November 14, 2014

NEMA Comments on Staff Analysis of Small Diameter Directional Lamp and Light Emitting Diode Lamp Efficiency Opportunities

NEMA Comments on Staff Analysis of Small Diameter Directional Lamp and Light Emitting Diode Lamp Efficiency Opportunities

DOE report: "Solid-State Lighting: Early Lessons Learned on the Way to the Market" Published January 2014
http://apps1.eere.energy.gov/buildings/publications/pdfs/ssl/ssl_lessons-learned_2014.pdf

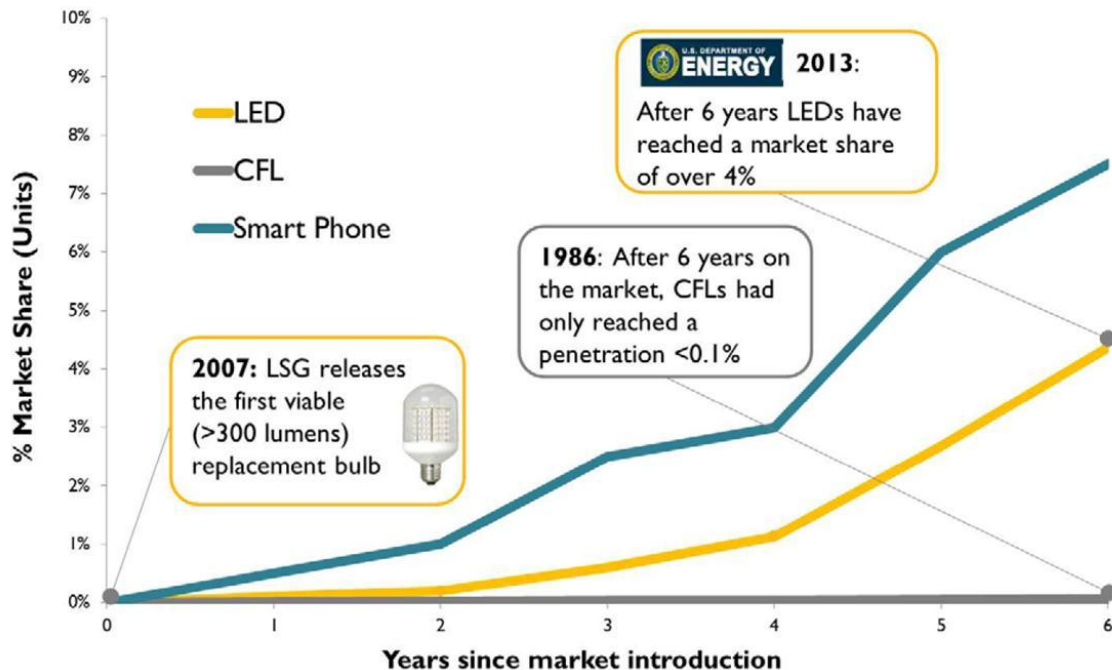
14. In response to the routine retrospective comments regarding challenges with early CFL designs, we note that the DOE has clearly demonstrated that SSL is being adopted radically faster than CFL was (see figure below). There is simply no comparison between the two adoption rates. It no longer makes sense, in light of this high adoption rate, to persist in thinking that there is an overwhelming need to put in place strict requirements for CRI and other characteristics based on old arguments that the CFL story will repeat itself. There is little to suggest that the adoption of LED will suddenly reverse itself, nor a reason to fear it.
